**ISSUE:** Certificate of Appropriateness for new construction

**APPLICANT:** City of Alexandria and Washington Metropolitan Area Transit Authority (WMATA)

**LOCATION:** Old and Historic Alexandria District  
2500 Potomac Greens Drive (2405, 2501, 3701 Potomac Avenue, 3251 Potomac Avenue [Parcel ID 016.04-01-01], 700 Carpenter Road, 1702 and 1880 Potomac Greens Drive) 2901 Potomac Avenue (2405, 2501, 3701 Potomac Avenue, 3251 Potomac Avenue [Parcel ID 016.04-01-01], 700 Carpenter Road, 1702 and 1880 Potomac Greens Drive)

The BAR has been reviewing this enormous project through an iterative, cumulative process. The applicant has requested approval of the following three items at this hearing. The remaining items will be brought forward on December 18, or whenever they are ready. Item numbers below reference a spreadsheet that the applicant has used at the past several hearings and is included in the linked staff report of October 16, 2019.

# Bridge Lighting Updates

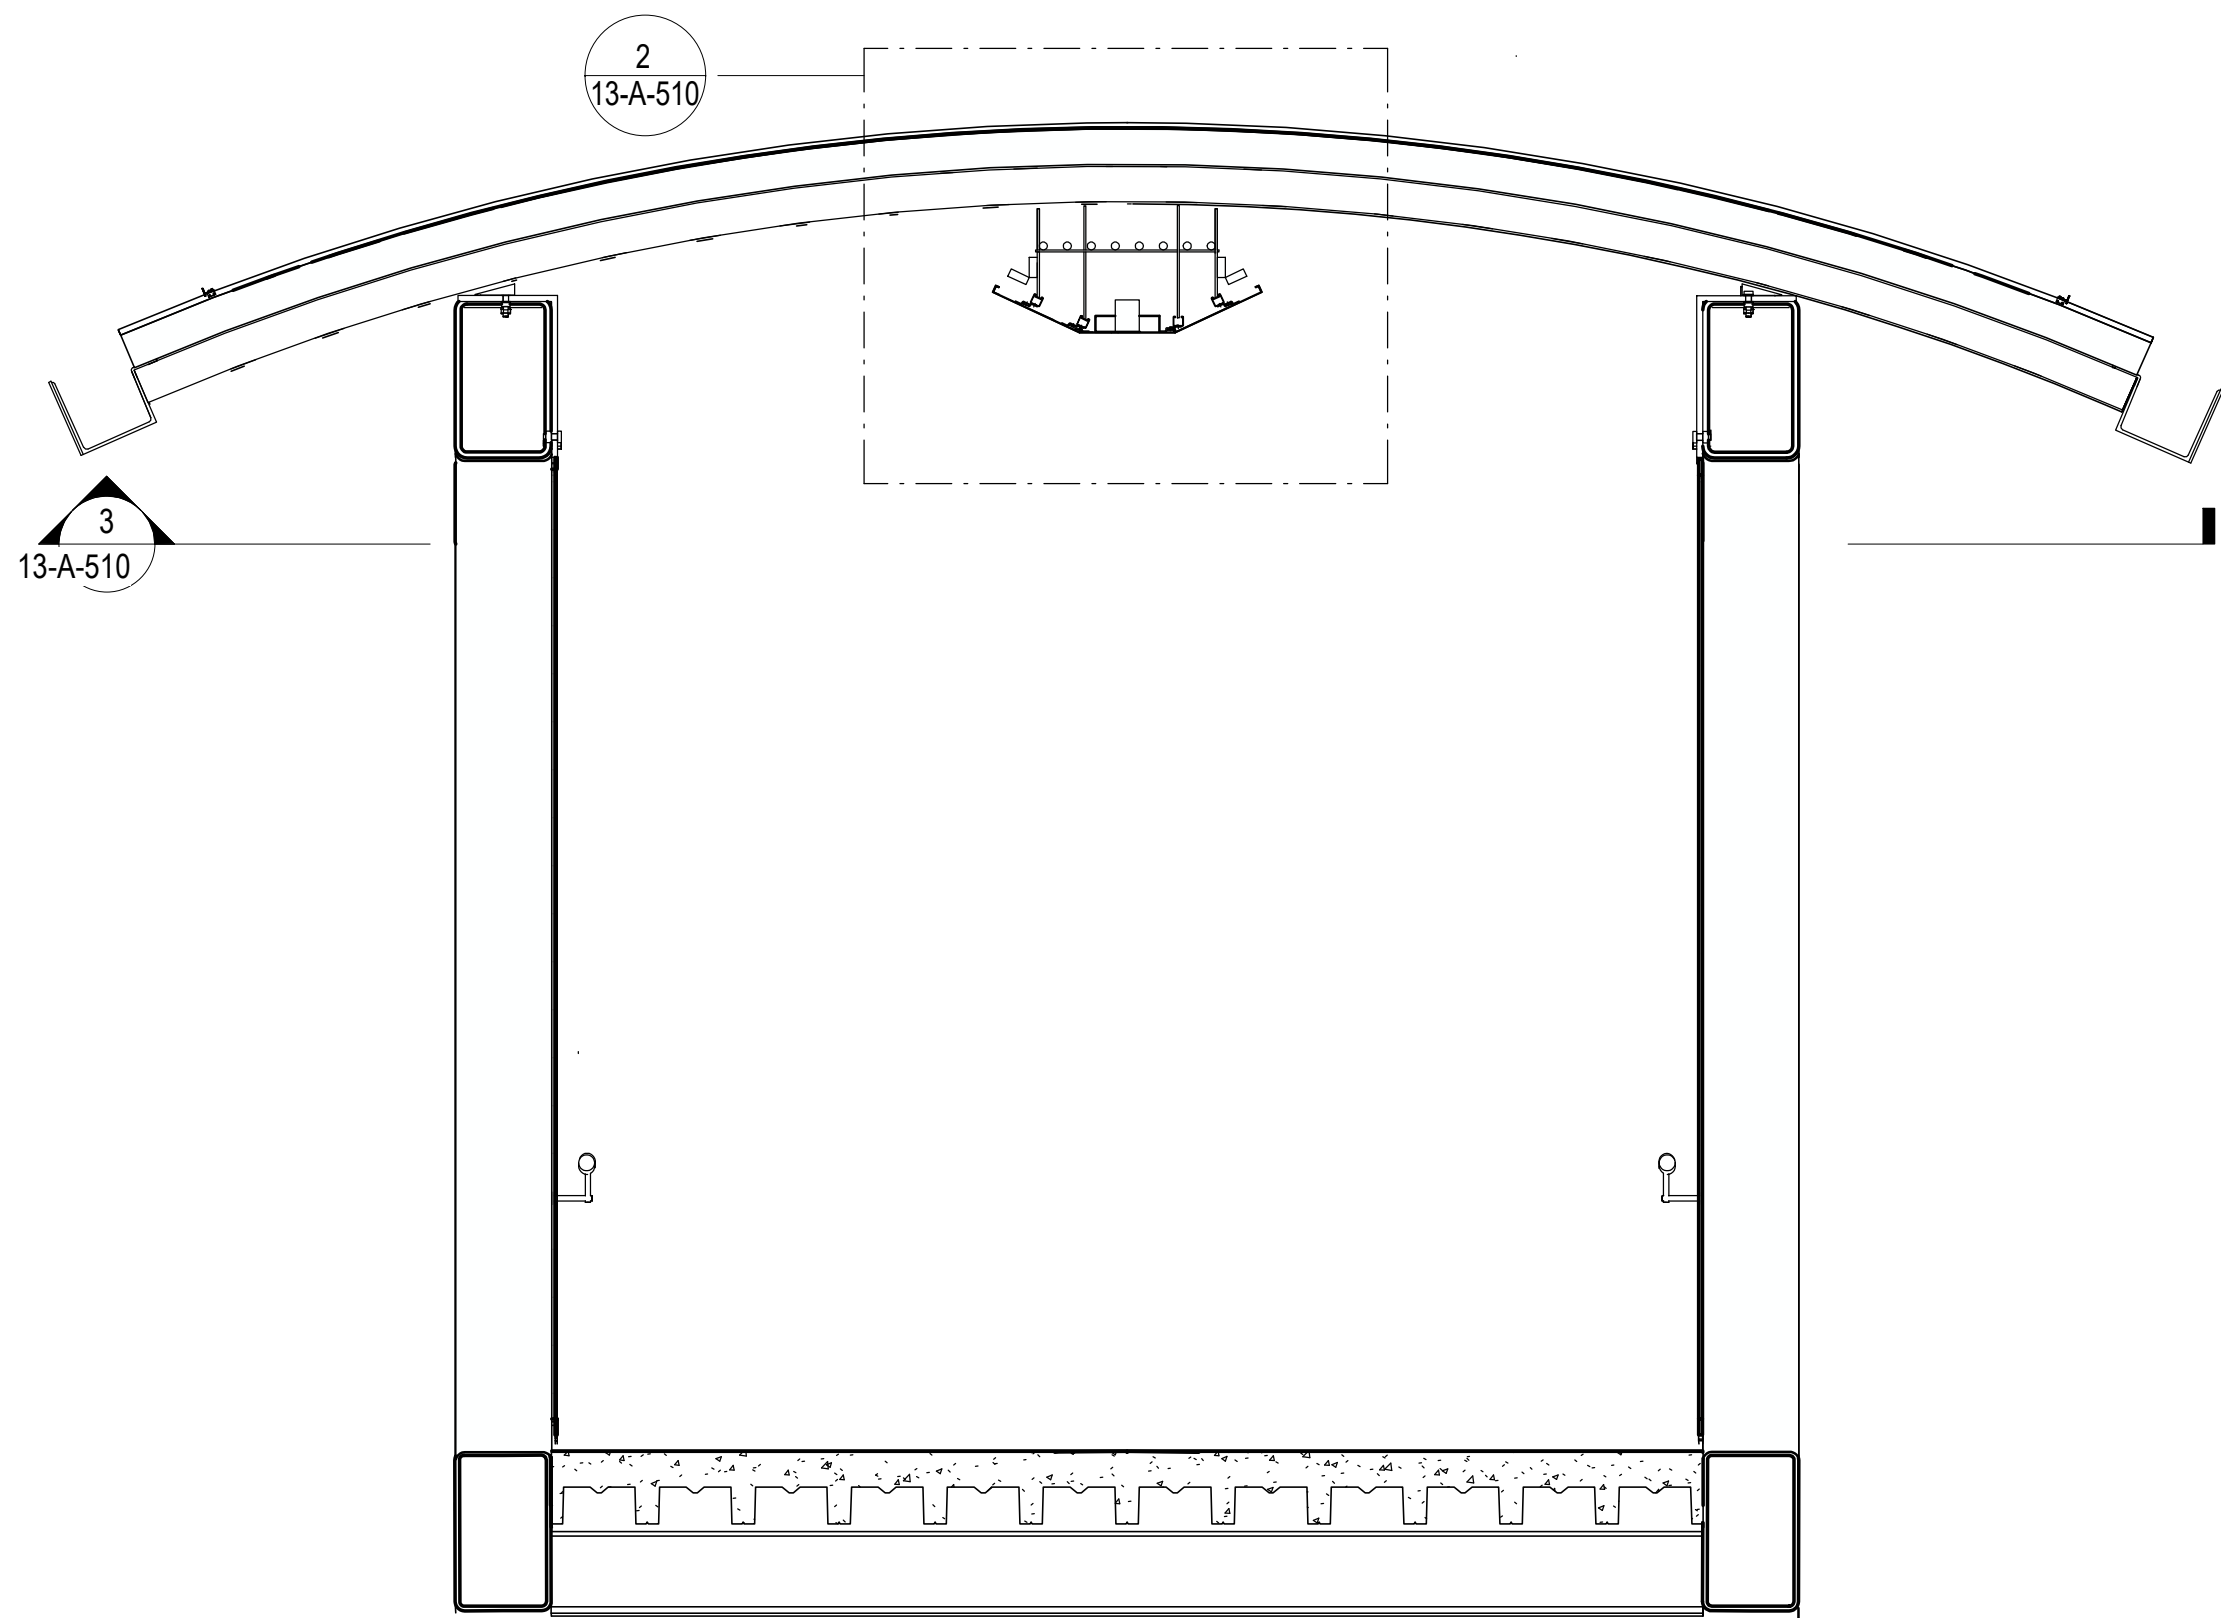
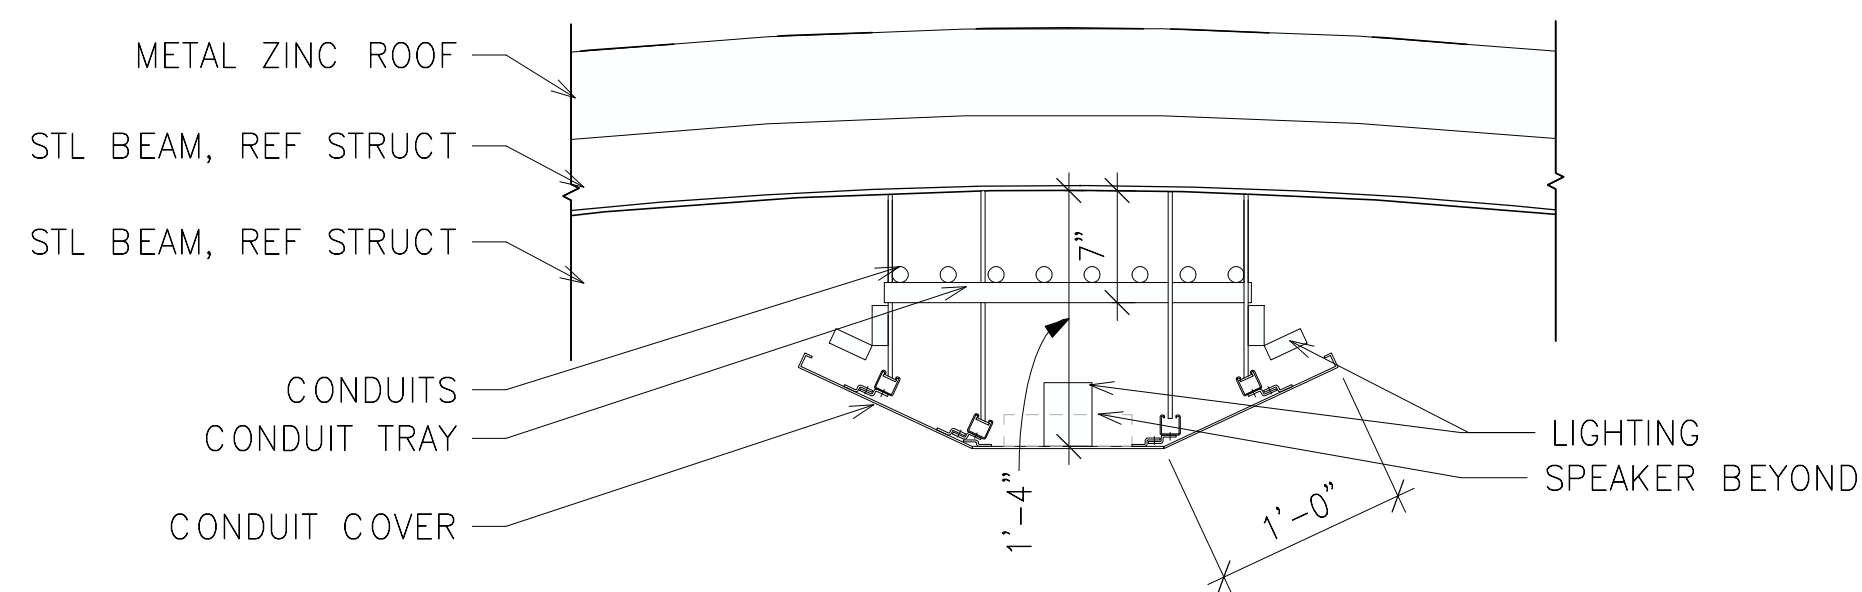
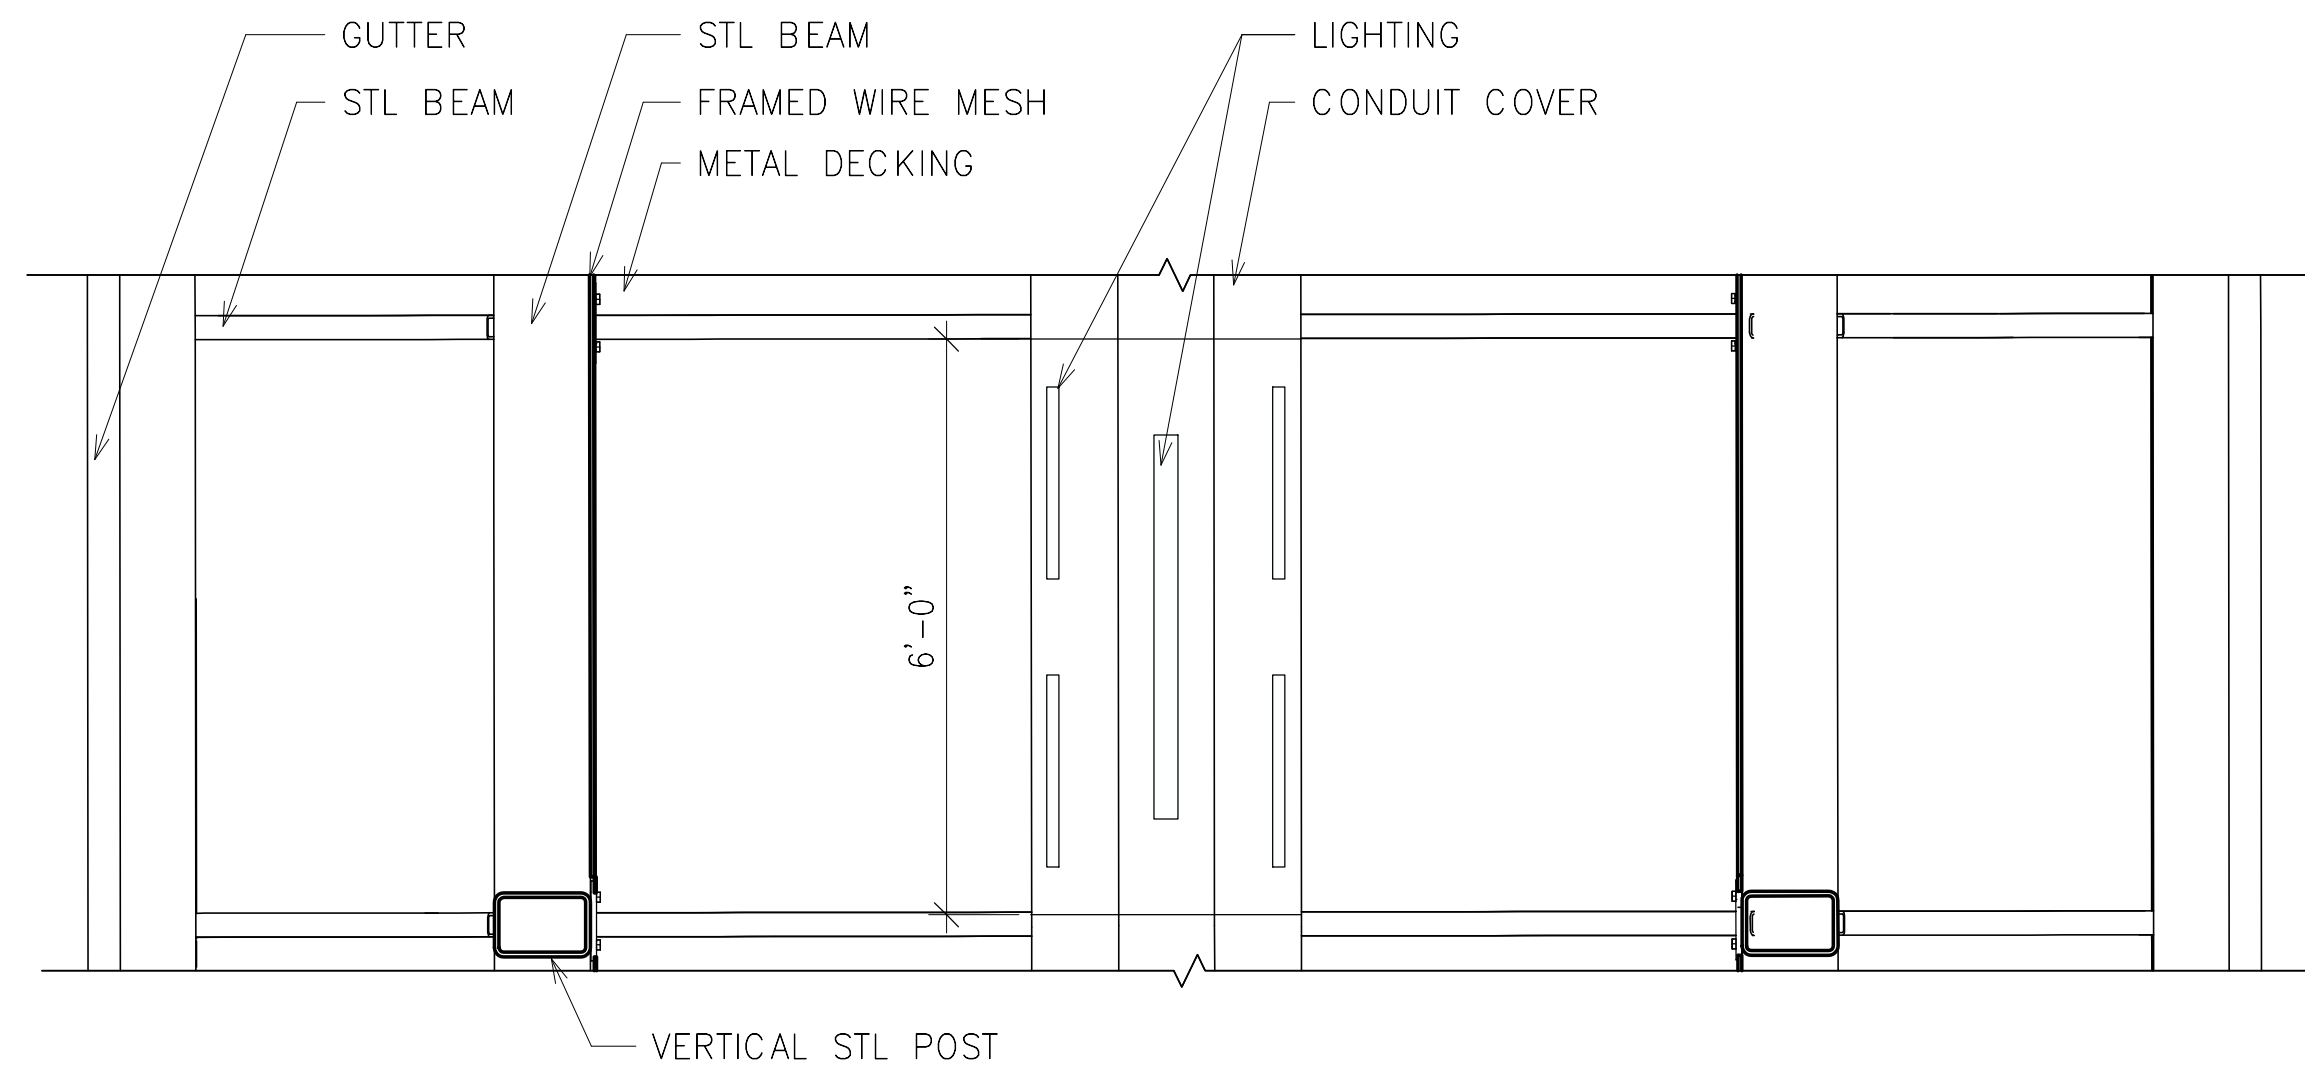
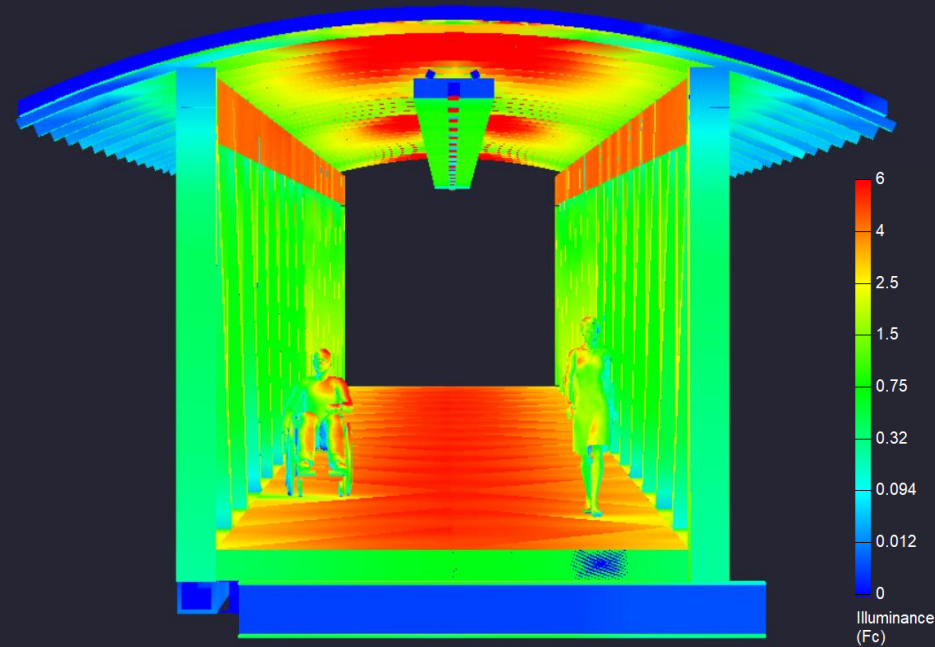
Finally, the applicant has removed the surface mounted light fixtures from the side of the truss of the pedestrian bridge and located them in a trough the center of the arched ceiling. This significant improvement has the positive effect of balancing the intensity of the light that washes both sides of the bridge ceiling. Some linear light fixtures will also direct illumination down toward the floor from the bottom of the trough. Light will be directed so that no light spills through the sides of the pedestrian bridge. Speakers will also be installed in the bottom of the trough. Equally important, removing all of the random conduit and pull boxes that were previously attached to the interior and exterior surfaces of the truss produces a much simpler and cleaner overall design.
